# Protocab

# UPDATE

THE NEWSLETTER OF CLUB PROTOCAB MANAGED BY ACC+ESS LIMITED- MANUFACTURERS OF THE PROTOCAB WIRELESS MODEL RAILWAY CONTROL SYSTEM

### The Revised Design

## 1201 - the votes so far

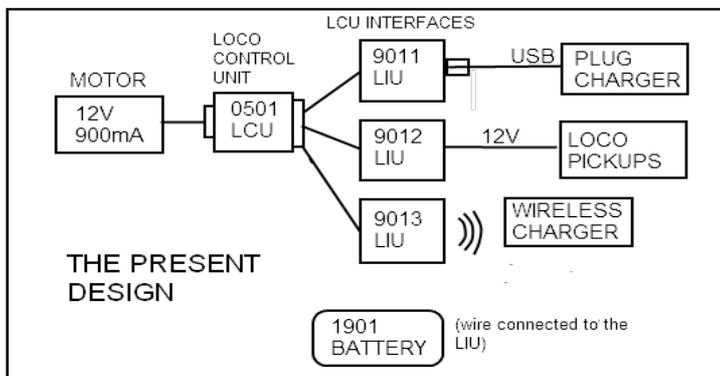
We've had a great response to our request for your preferences for the three proposed designs for the 1201 shown in newsletter 6 and a number of useful comments about usability. There were also a number of questions about design and, for example, how the locos are allocated to the buttons. From the responses received so far, the percentage votes to date are:

Button throttle	50%
Wheel throttle	50%
Lever throttle and brake	0%
(there were considerably more than two votes!)

Some updates from modellers' responses: you want more than six loco selection buttons. The plan is that you allocate a loco in your fleet to each button, and press the respective button to select a loco to drive. 9 buttons have been suggested, but questions have been asked about what happens when you take the loco to a friend's or club layout. We think that these responders are thinking about

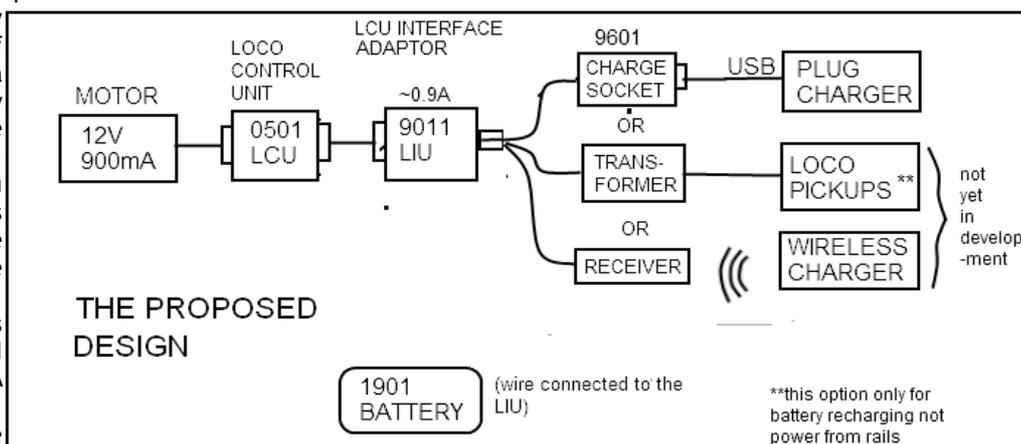
Taking the charging socket off the 9011 LIU will reduce the footprint of the 9011 and increase the flexibility of

recharging power will need to be transformed from track voltage to the LIU input voltage. This new arrangement means that we can cater more simply for different fixed track voltages e.g. 12V DC or 16V AC, by having different models of transformer. It also simplifies the situation where, for example, modellers want to run Protocab-fitted locos on a DCC fitted layout and charge the battery from the track.

3. The receiver for wireless charging will enable this unit to be placed between the frames with greater ease than having it located on the LIU.

where to locate the LCU, LIU and charging socket. The proposed plan (below) has other new features. We no longer need separate models of the LIU for a specific voltage/current output. Instead, we provide separate units to connect to the LIU. From the top of the drawing:

1. The new model 9601 charge socket will now be around 10mm x 11mm x 8mm with three wires that are connected to the LIU. This means a third connector on the LIU which now measures 26x13mm.

2. The transformer that is used to connect the LIU to loco pickups for contact
